INDEPENDENT REVIEW OF 2014 DAM SAFETY INSPECTION REPORT

Huckleberry Tailings Dams

Reference Number: 051413474-143-R-Rev0-2214

Photograph Showing Relationship of Pond Level, Till Core, Filters and Rockfill at TMF-3

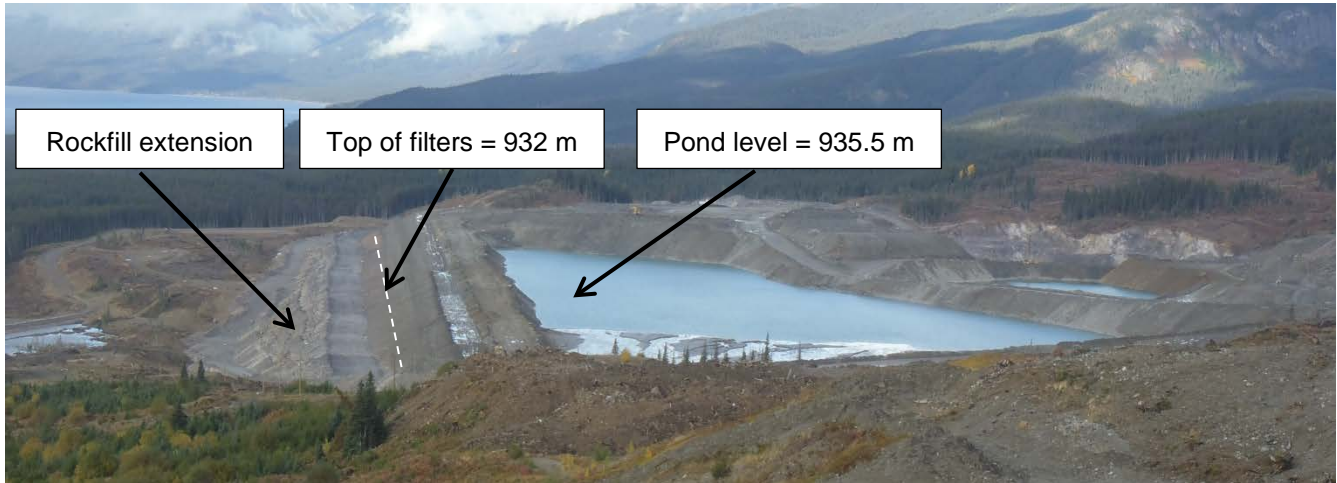
At the time of Golder’s site inspection, the placement of filters and rockfill to the TMF-3 Main Dam and Saddle Dam was lagging behind the placement of till core.

This situation (October 6, 2014, data) is shown graphically below and in Photograph 13 in Appendix A.

Golder agrees with BGC that impoundment of water above the level of protected filters represents a potential dam safety concern. Sustained operation of the dam with a core not protected by filters and not supported by rockfill may result in the potential for piping failures or unintended downstream movement and cracking of the core. Maximum allowable pond levels for future construction should be reviewed with BGC.

Golder recommends that HML and BGC should review the water management strategy, tailings deposition plan, and dam raise schedule for filter and rockfill placement. This should include review of the sensitivity of the TMF-3 system to changes in water management strategies, such as varying rates of reclaim.

TMF-3 Cross-Section at Sta 1+500 (modified from BGC 2014)

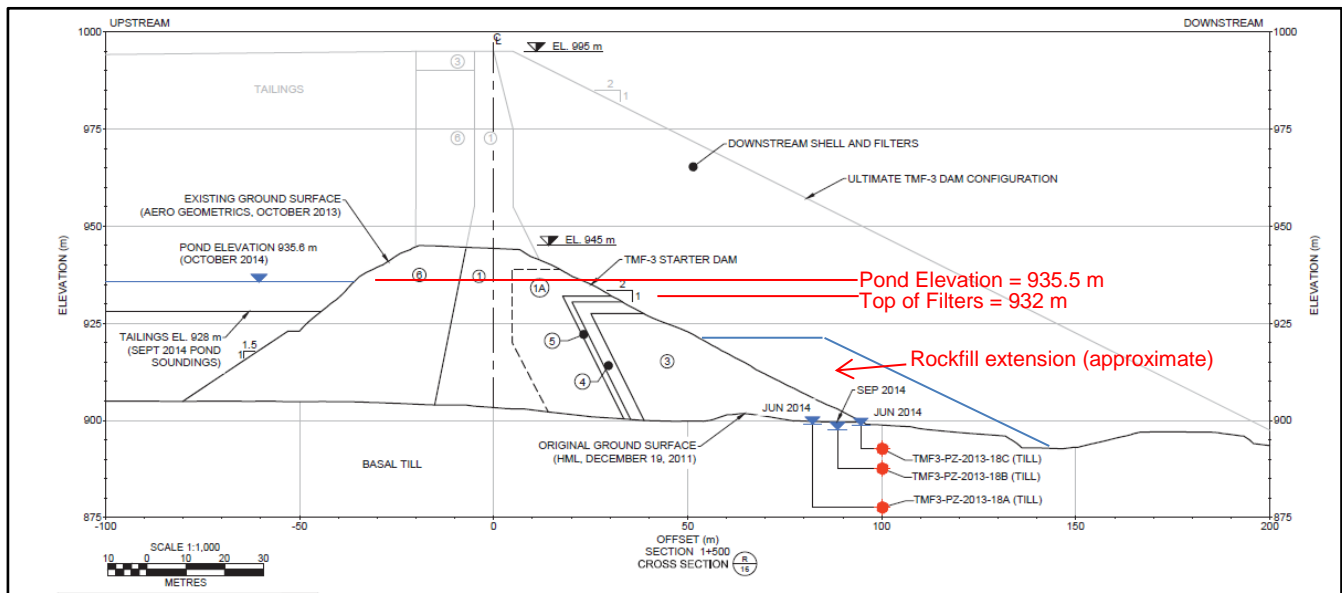
On October 6, 2014, BGC reported the following elevations for the TMF-3 Dam:

| ■ Zone 1 till core | 945 m |
| ■ top of weighted filter zone | 932 m |
| ■ pond elevation | 935.5 m |

In October 2014, BGC Engineering Ltd. provided an assessment of the potential dam safety hazard presented by this scenario (Appendix K of BGC 2014) and provided maximum allowable pond levels for filters at El. 932 m. Mitigation measures were developed by HML and BGC to reduce the pond level in TMF-3 to levels that do not present a dam safety concern. The mitigation plans are considered appropriate. It is further understood that raising of the filters and rockfill is in progress at the time of writing, and that filters are expected to be above the pond water level by early December and at about El. 940 m in January 2015. Ongoing implementation of the mitigation strategies (particularly reducing the pond level and raising the filters and rockfill) should be given high priority.
